**Department of Community Planning and Economic Development**  
Variances  
BZZ 6420

**Address of Property:** 1100 and 1118 University Avenue NE

**Proposed Use:** Three new monument signs

Department of Community Planning and Economic Development Report  
BZZ-6420

**DRIVE-THRU SIGNAGE  
EXHIBIT 1**

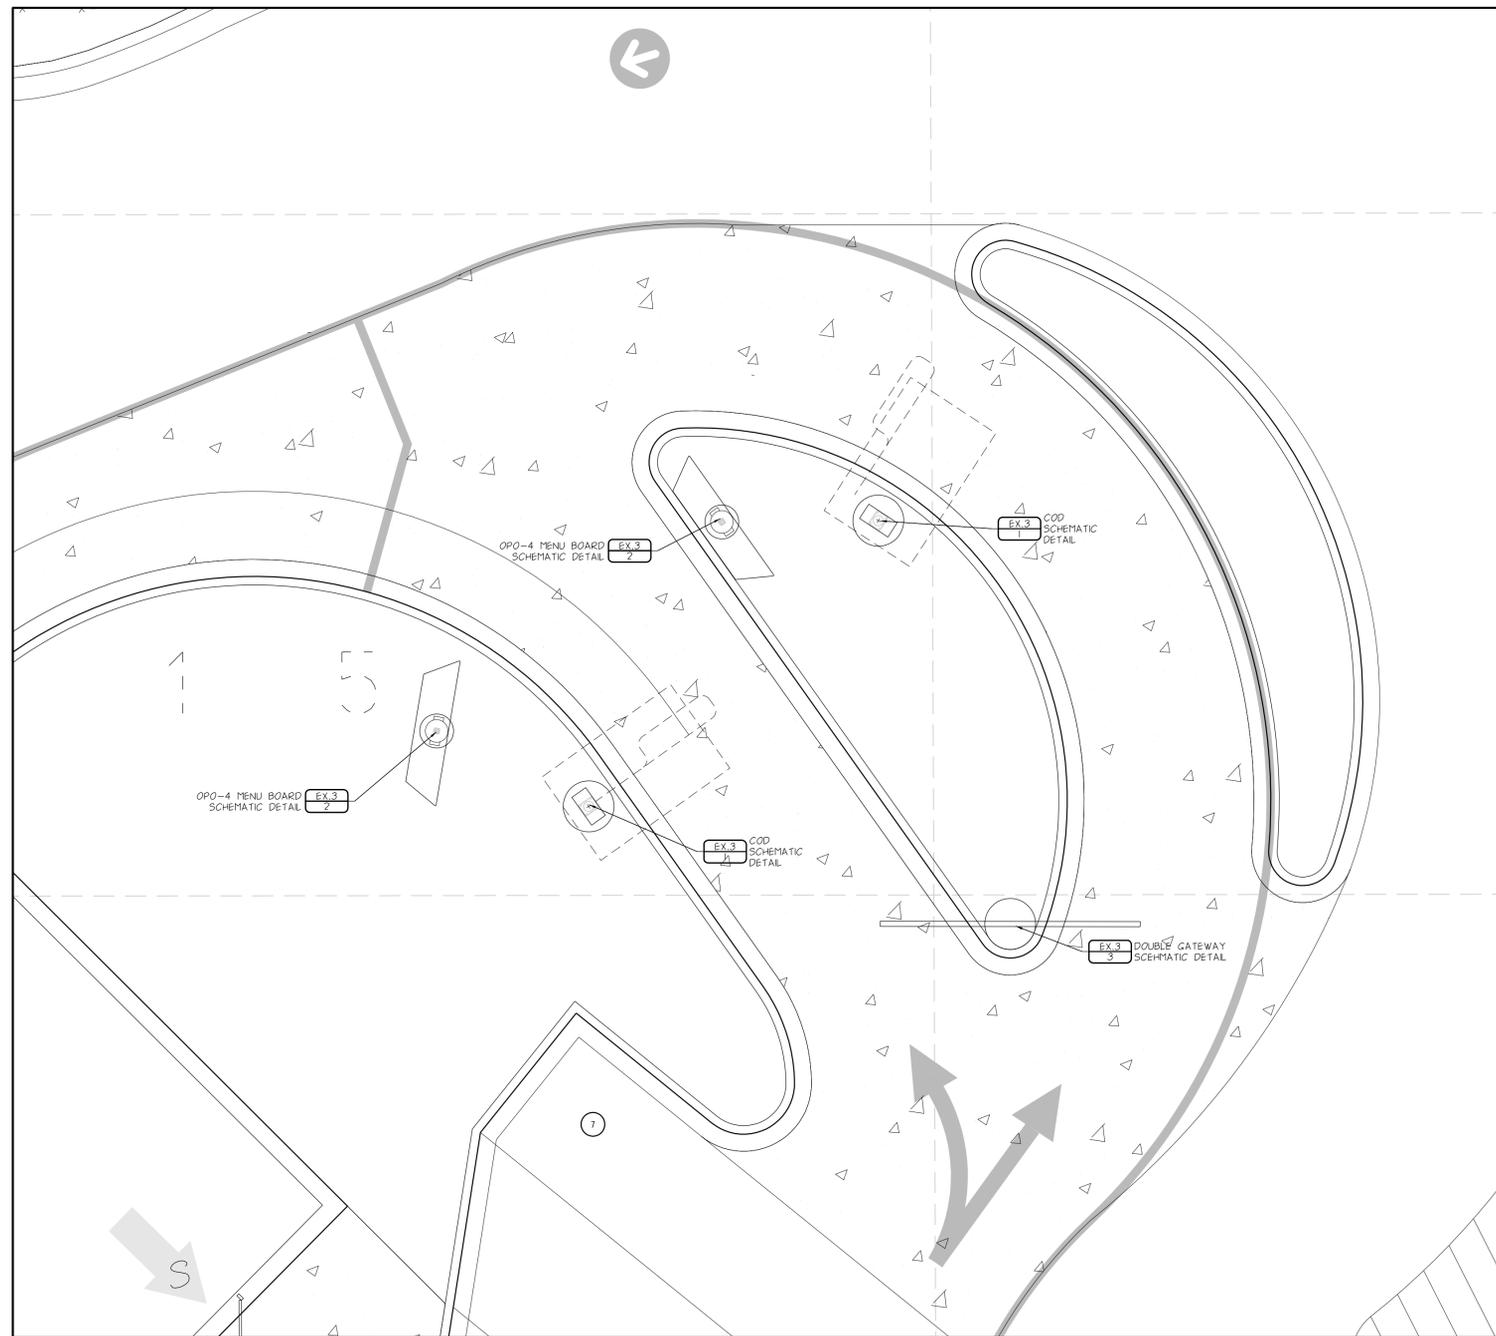
- Variance to increase the number of freestanding signs from one to four.
- Variance to increase the maximum area of freestanding signs from 80 square feet to 330 square feet.
- Variance to increase the maximum height of a menu board from 6 feet to approximately 6 feet 9 inches.
- Variance to increase the maximum height of a freestanding signs from 8 feet to approximately 10 feet 3 inches and 10 feet 9 inches.

existing pole sign, 223 square feet in area, which will remain on the property. The applicant is proposing to add two canopy signs 4.32 square feet per canopy, one double gateway sign, 16.3 square feet in area and two menu boards which will include 41 square feet. The maximum number of freestanding signs for this property is one. Therefore, the applicant is seeking a variance to increase the maximum number of freestanding signs from one to four. The maximum area for all freestanding signs on a property in the C2 Neighborhood Corridor Commercial District cannot exceed 80 square feet. The total proposed sign area will be 330 square feet and the applicant is seeking a variance to exceed the maximum area allowed. There is one existing menu board, which will be replaced with two menu boards with the same height and area. The menu boards will be 6 feet 9 inches in height, where the maximum menu board height cannot exceed 6 feet. Therefore the applicant is seeking an additional variance to increase the height of the menu boards. Finally, the canopy signs will be 10 feet 3 inches in height and the directional drive-thru sign will be 10 feet 9 inches in height. The maximum height of a freestanding sign cannot exceed 8 feet and the applicant is seeking a variance.

The Department of Community Planning and Economic Development recommends that the Board of Adjustment adopt staff findings and **approve** the variance to increase the number of freestanding signs from one to four for the properties located at 1100 and 1118 University Avenue NE in the C2 Neighborhood Corridor Commercial District, subject to the following condition of approval:

1. Approval of the master sign plan by the Department of Community Planning and Economic Development.
